SUBJECT: **Item 8-Detailed Site Plan DSP-21024**  
**EcoGrads**  
Planning Board Agenda September 29, 2022 – Staff Revisions to Technical Report

The applicant revised their proposal after the technical staff report was filed, and this supplemental memo provides updated findings, recommendations, and conditions in response to the revised proposal. The revised plans are attached as Exhibits AE1, AE2, AE3, and AE4 and are included in the additional backup.

# Detailed Site Plan EcoGrads

SUBJECT: Detailed Site Plan DSP-21024  
EcoGrads

**Figure 9: Building Form exhibit from the Central US 1 Corridor Sector Plan**

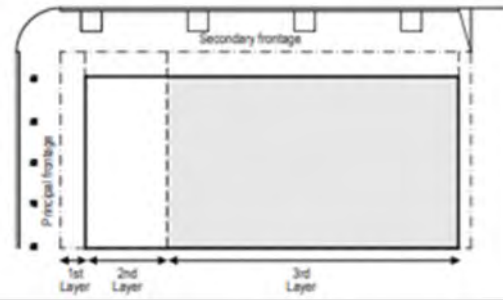
- a. **Page 234-Building Form/Setback:** In the Walkable Node, the principle front build-to-line shall be a maximum of 10 feet. The ground floor of the proposed building is set back 12.5 feet to provide for outdoor seating and dining. The remainder of the building on the upper stories varies from 3.5 feet to 21.5 feet.

The applicant states that the unique design of the building with the saw-tooth façade at Levels 2–7 has been designed to address the spirit of the build-to-line, and the setback at street level will provide space for safe and efficient outdoor seating along US 1 in front of the ground floor and allow for the ability to provide street amenities envisioned in the sector plan. The placement of the building provides area for landscaping with street trees and separation between the sidewalk and the travel lanes along US 1. Lastly, the applicant notes that the building placement is necessary to provide an increased build-to-line due to existing storm drains along the frontage of the property. Therefore, staff recommends **approval** of this amendment.

# DETAILED SITE PLAN – (AMENITIES - PEDESTRIAN & BICYCLE EXHIBIT)

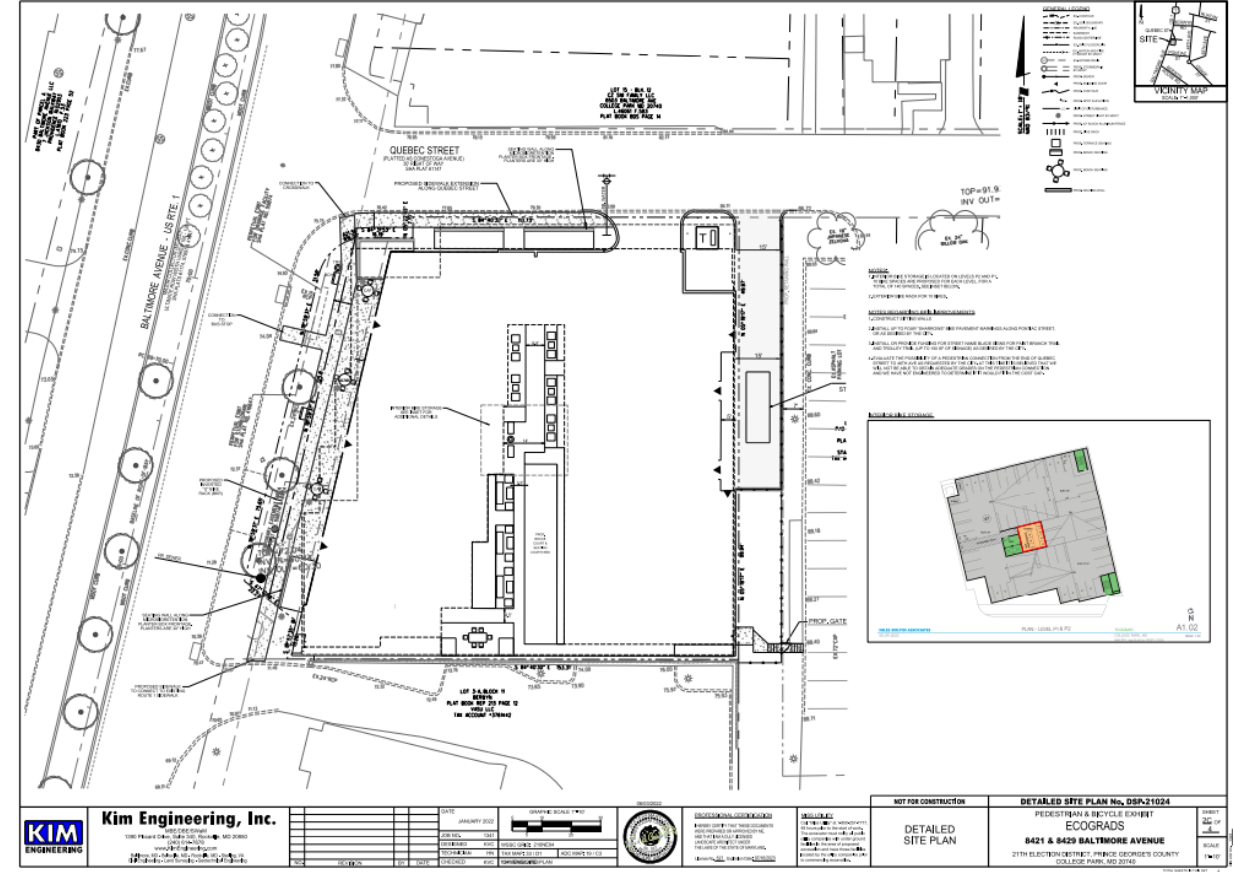
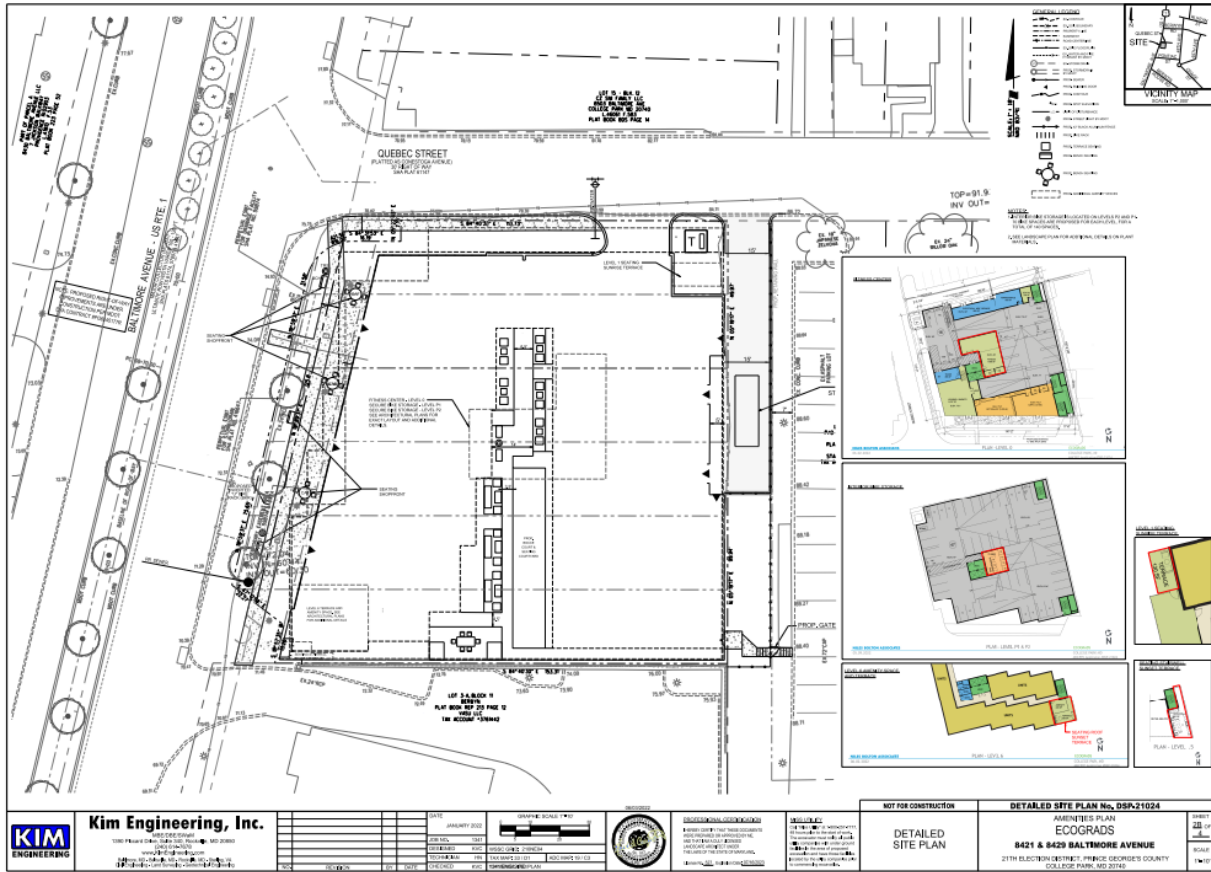
- j. Update Sheet 2C to replace the word “Exhibit” to “Plan”
- k. In accordance with condition 1a, update the Pedestrian and Bicycle “Plan” to include all off-site pedestrian and bicycle improvements, in accordance with approved Preliminary Plan of Subdivision 4-21039.

Sheet 2C of the DSP plan set shows the bicycle and pedestrian facilities plan required by Conditions 8 and 10. It is noted that this sheet provides notes regarding the off-site BPIS improvements rather than depicting them. Per Condition 11 of the PPS, prior to certification of the PPS it was determined feasible to restripe approximately 22 shared roadway pavement markings (sharrows) along Berwyn Road between US 1 and the train tracks east of the site. The notes on Sheet 2C accordingly list this off-site improvement alongside the ones specified in Conditions 9a and 9b. The Transportation Planning Section should determine whether the DSP conforms to Conditions 7-10.
